Access Compliance Report Public Rights-of-Way (Curb Ramps)

Main Street: MEANDERING_TRAIL		Cross Street: GRASSY_KNOLL_LN		Location:	SW
ADA ID: RPRK211019132052	Ramp Type: Type 4 - Parallel	Initial Pass/Fail: Fail	Overall Compliance: No	Severity Score:	15
Codes/Mitigation Info/Possible Solution			Field Measurements/Component Compliance

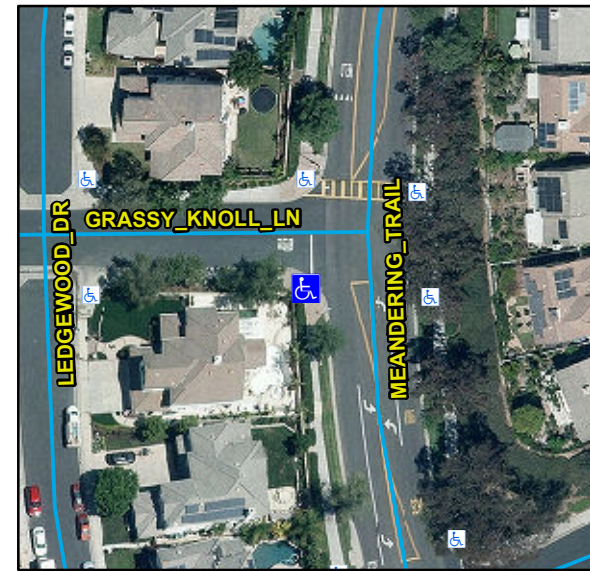
Compliance	Description	Data	Compliance	Description	Data
N/A	Ramp Length LT (in)	86	N/A	Ramp Length RT (in)	91
Yes	Ramp Width LT (in)	94	Yes	Ramp Width RT (in)	91
Yes	Ramp Run Slope LT (%)	3.5	Yes	Ramp Run Slope RT (%)	3.4
No	Ramp Cross Slope LT (%)	5.4	No	Ramp Cross Slope RT (%)	4.6
N/A	Landing Present	N/A	N/A	DWS Provided	N/A
N/A	Landing Length (in)	N/A	N/A	DWS Contrast	N/A
N/A	Landing Width (in)	N/A	N/A	DWS Length (in)	N/A
N/A	Landing Run Slope (%)	N/A	N/A	DWS Full Width	N/A
N/A	Landing Cross Slope (%)	N/A		DWS Offset Type	N/A
N/A	Landing Movement Obstructed?	N/A	N/A	DWS Offset Left (in)	N/A
	Landing Movement Type	N/A	N/A	DWS Offset Right (in)	N/A
N/A	Landing Shared	N/A			
N/A	Clear Space	Yes			
N/A	Clear Space To Crosswalk (in)	N/A			
N/A	Marked Crosswalk 1	No	N/A	Marked Crosswalk 2	No
	Crossing 1 Direction	E		Crossing 2 Direction	N
	Marked Crosswalk 1 Width (in)	N/A		Marked Crosswalk 2 Width (in)	N/A
N/A	Ramp Inside Crosswalk 1	N/A	N/A	Ramp Inside Crosswalk 2	N/A

Remove & Replace Curb Ramp With Two New Directional Ramps or Equivalent.

R204.3, R304.5.3, STD 1115
